TITLE OF INVENTION: Wine Case

Notice of Allowability For A Design Application	Application No. 29/895,014	Applicant(s) Alexander, Barry	
	Examiner AMANDA K BIRDWELL	Art Unit 2931	AIA (FITF) Status Yes

RESPONSE TO OFFICE ACTION

FIG. 1

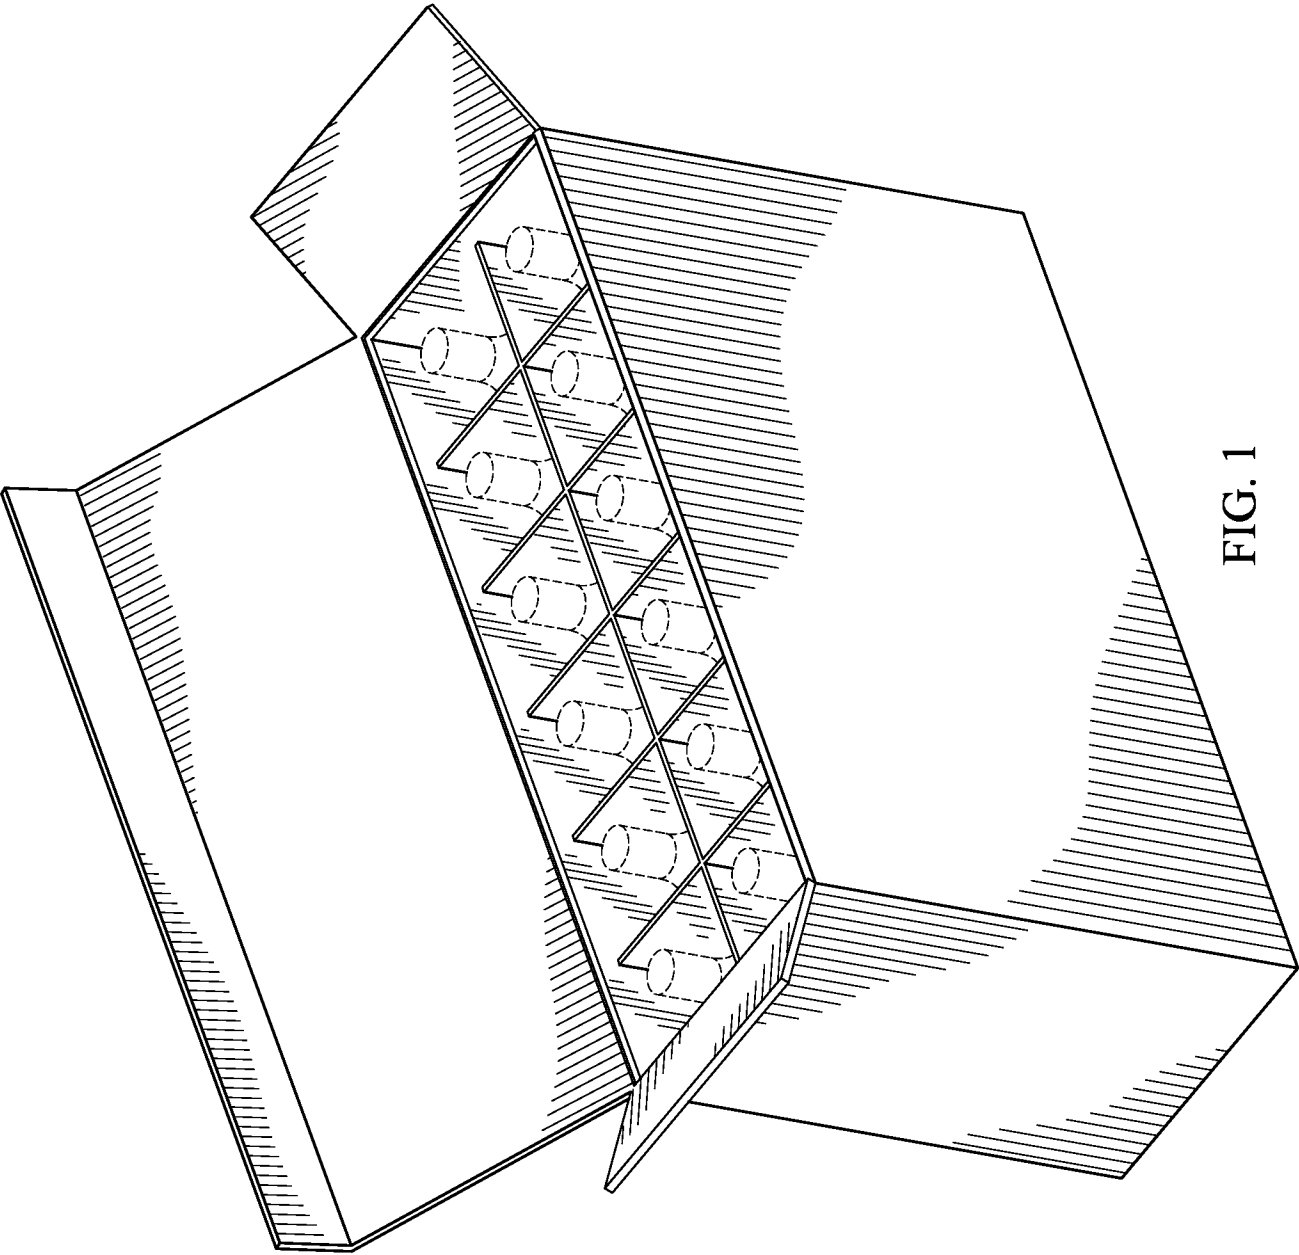
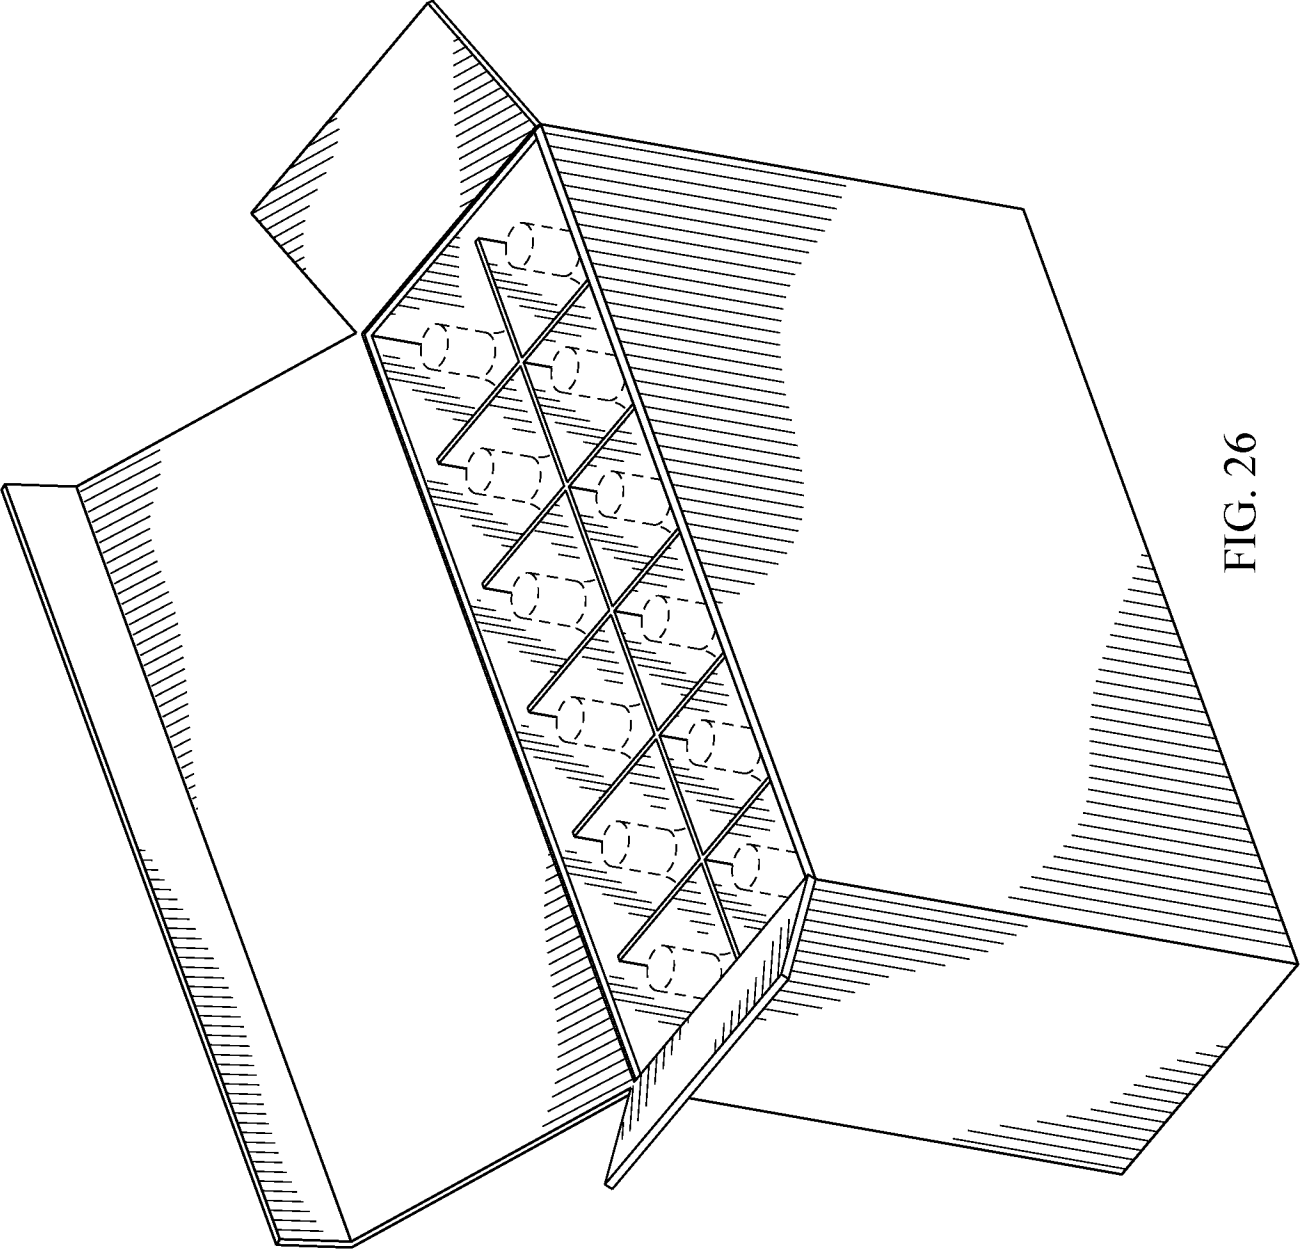
FIGS. 26, 28 and 33 show the appearance of the wine box inconsistently with each other.
Specifically, Figs. 26 and 33 contain a small line in the corner of the wine case, which is not shown in Fig. 28.

Figure 1 (formerly Figure 26) has been amended to delete a stray line in the front right corner of the box to make it consistent with Figure 3 (formerly Figure 28), as recommended by the examiner.

FIG. 2

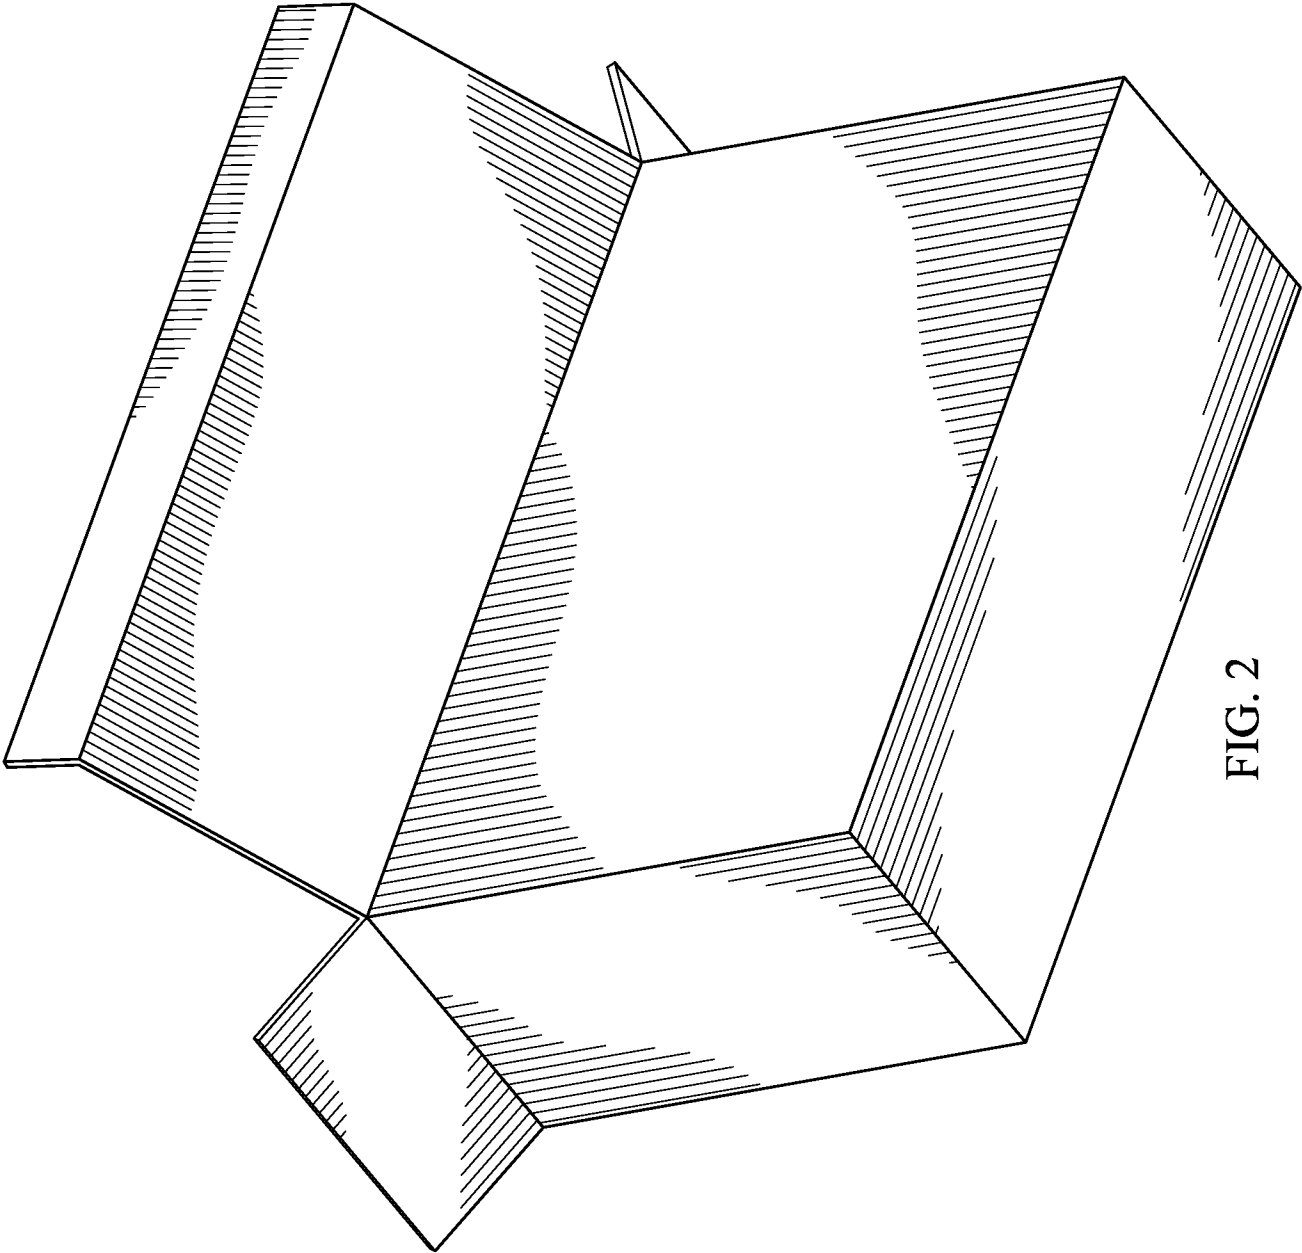
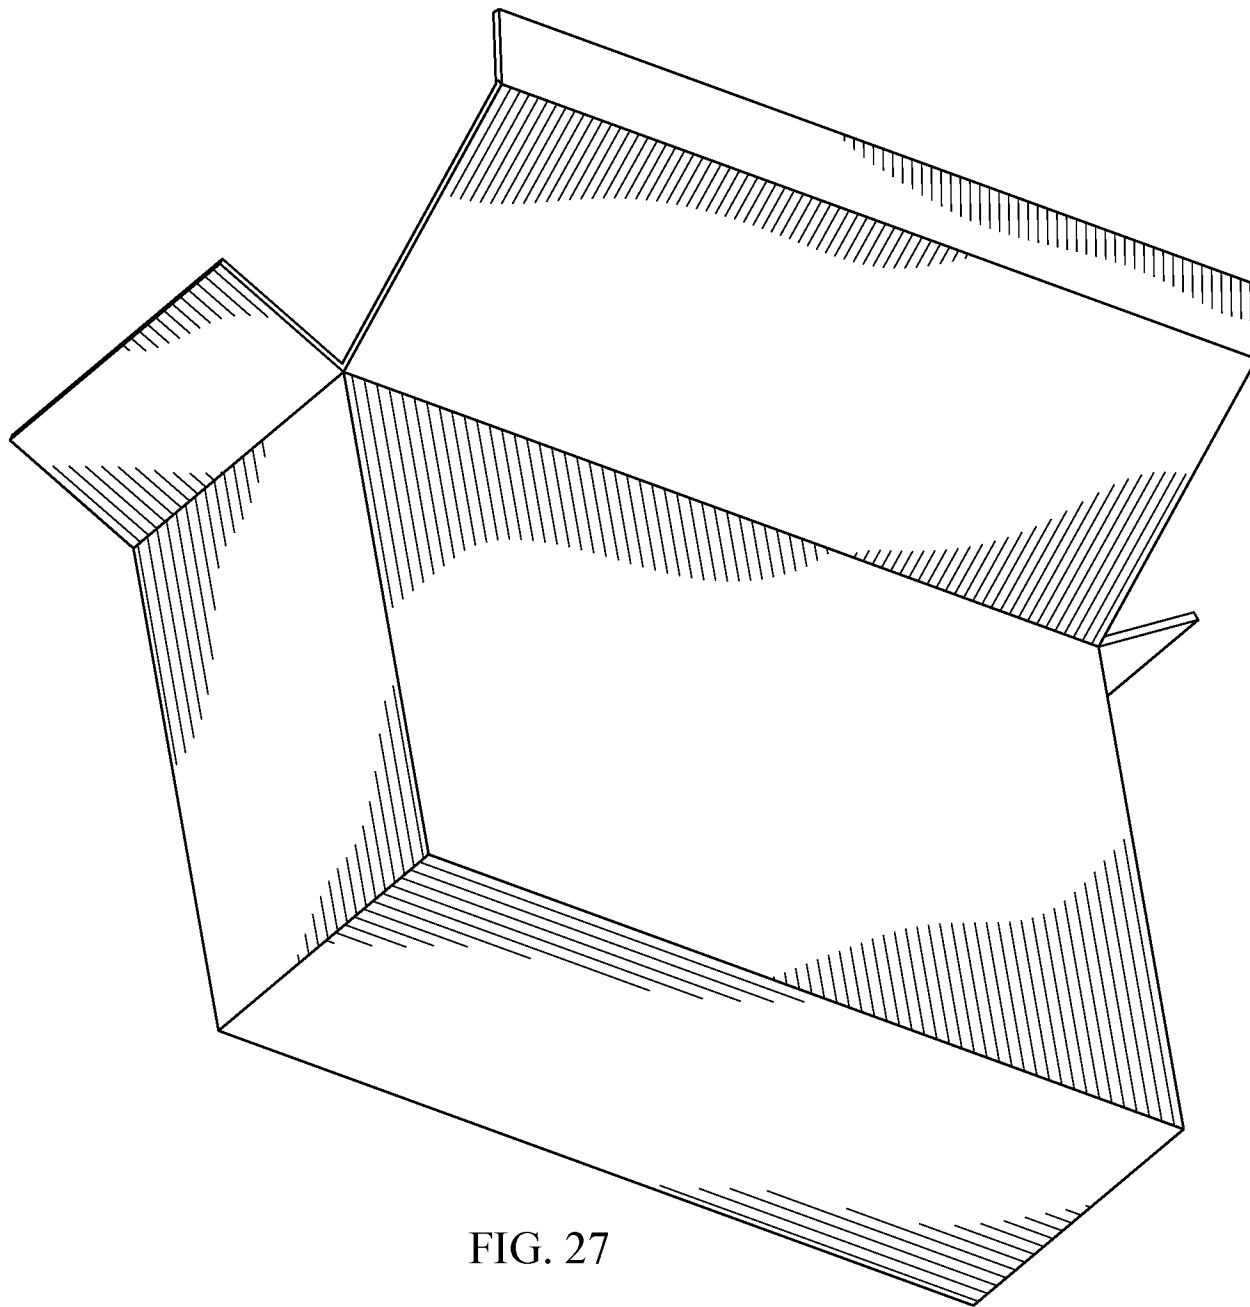
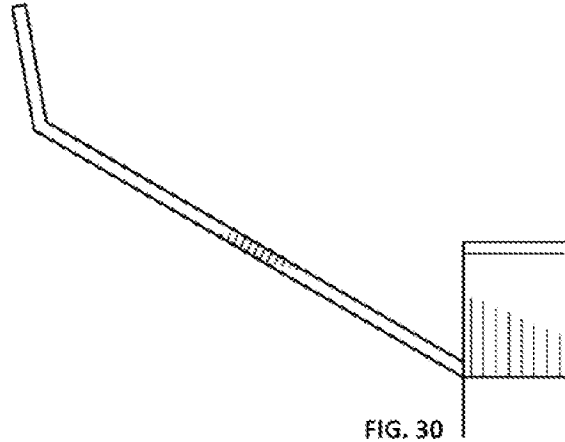
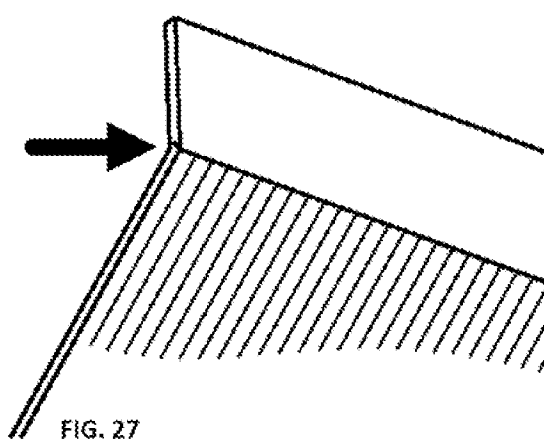
Fig. 27 is objectionable because it shows the appearance of the wine case inconsistently with the other drawings. Specifically, Fig. 27 shows a small score line between the first and second portions of the top flap of the wine case. This score line cannot be corroborated by any of the other drawings. Correction must be made for consistency.

Figure 2 (formerly Figure 27) has been amended to delete a stray line at the corner of the box top to make it consistent with Figure 5 (formerly Figure 30), as recommended by the examiner.
